RSB 560
Jan 19, 2021

NHTSA #20V 719
TC #2020-556

RECALL SERVICE BULLETIN

EN 20E071 Recall Remedy – Manifold Bolt and Valve Seal Replacement Service Kit Instructions

5 Remove the Manifold Pipe

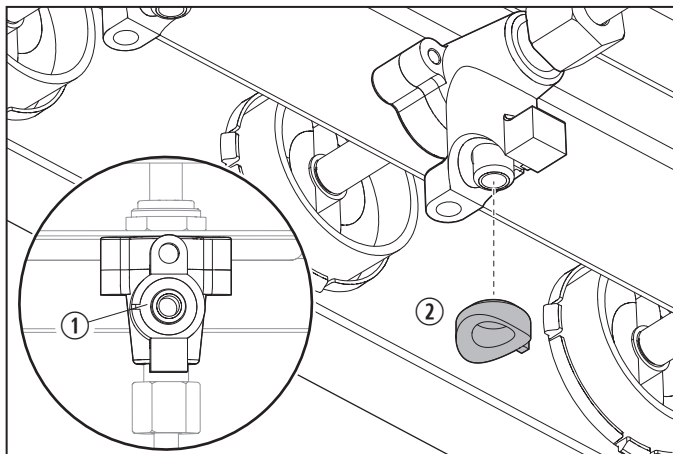
The manifold pipe must be lowered to access the valves.

1. Using a socket wrench, remove the four manifold bolts.
2. Lower the manifold pipe from the burner valves.

6 Replace the Valve Seal

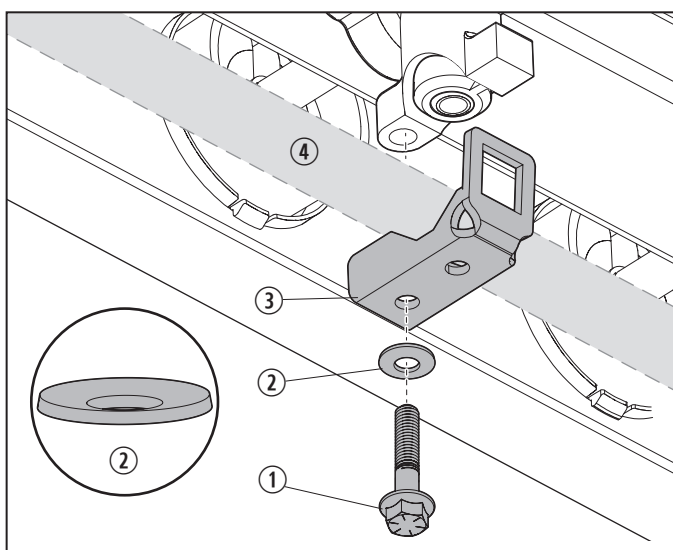
1. For each burner valve, replace the black valve seal with a red valve seal (provided). Do not replace the black seal for the oven thermostat valve.
2. For the burner valves, make sure the tab on the red valve seal sets in the recess in the valve.
3. Dispose of the removed black valve seals and manifold bolts according to "Disposal" on page 5.

7 Install the Bell Washers

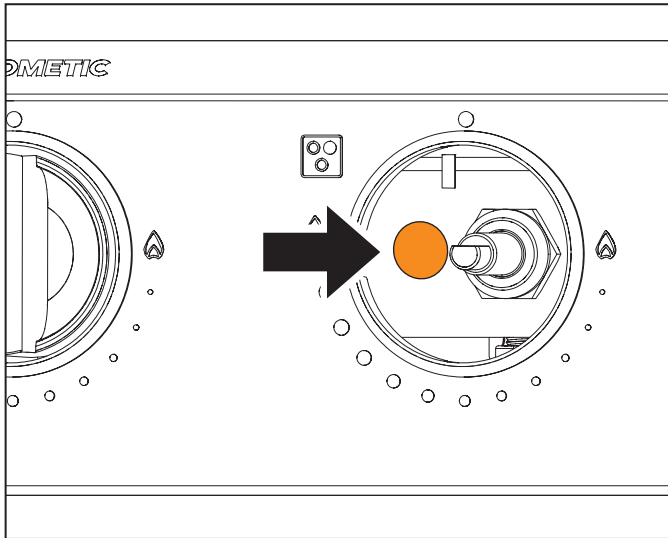
1. Place a bell washer (provided) over each of the four threadlocker bolts (provided). Make sure the bell washer is placed in the correct orientation as shown in Figure 7.
2. Assemble the manifold bracket to each valve while turning the threadlocker bolts finger tight.
3. Torque each threadlocker bolt to 15–20 in-lbs with a torque wrench.

i Exceeding recommended torque could damage components and cause a possible gas leak.
